Access Compliance Report

Public Rights-of-Way

Intersection ID: 29510	Main Street: LYNMONT_DR	Cross Street: CRESCENT_DAY_CT	Location: SW
ADA ID: B8C66237F401	Ramp Type: PerpDiag	Initial Pass/Fail: Fail	Overall Compliance: No
		Severity Score: 10

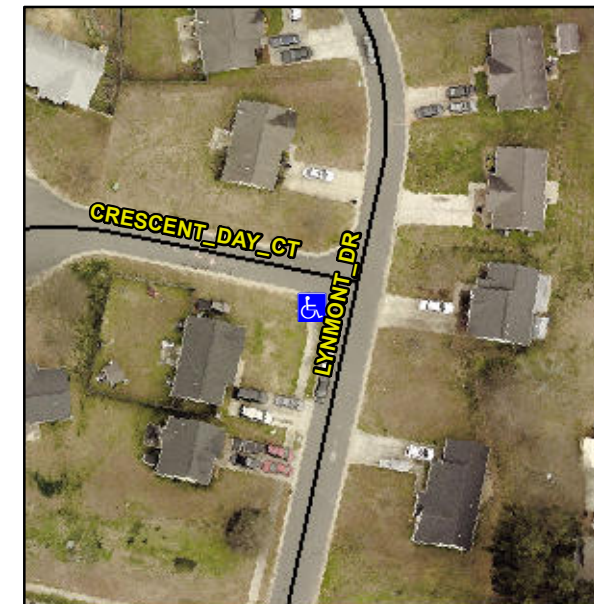
Not Found, R304.5.1, R304.5.3

Compliance	Description	Data	Compliance	Description	Data
N/A	Ramp Length (in)	51.0	Yes	Ramp Slope (%)	8.2
No	Ramp Width (in)	41.0	No	Ramp XSlope (%)	3.5
N/A	Flare Type LT	N/A	N/A	Flare Type RT	N/A
N/A	Flare Slope LT (%)	N/A	N/A	Flare Slope RT (%)	N/A
N/A	Flare Traversable LT?	N/A	N/A	Flare Traversable RT?	N/A
N/A	Landing Length (in)	N/A	N/A	DWS Provided?	N/A
N/A	Landing Width (in)	N/A	N/A	DWS Contrast?	N/A
N/A	Landing Slope (%)	N/A	N/A	DWS Length (in)	N/A
N/A	Landing X Slope (%)	N/A	N/A	DWS Full Width?	N/A
N/A	Landing Curb? (Y/N)	N/A	N/A	DWS Offset (in)	N/A
N/A	Shared Landing?	N/A			
N/A	Gutter Ponding?	N/A	N/A	Gutter Slope (%)	N/A
N/A	Gutter Lip Ht (in)	N/A	N/A	Gutter X Slope (%)	N/A
N/A	Painted X Walk1?	No	N/A	Painted X Walk2?	No
	X Walk 1 Direction	To E		X Walk 2 Direction	To N
N/A	X Walk 1 Width (in)	N/A	N/A	X Walk 2 Width (in)	N/A
	X Walk 1 Slope (%)	4.1		X Walk 2 Slope (%)	0.7
	X Walk 1 X Slope (%)	2.1		X Walk 2 X Slope (%)	3.0

Remove & Replace Curb Ramp With Two New Directional Ramps or Equivalent.
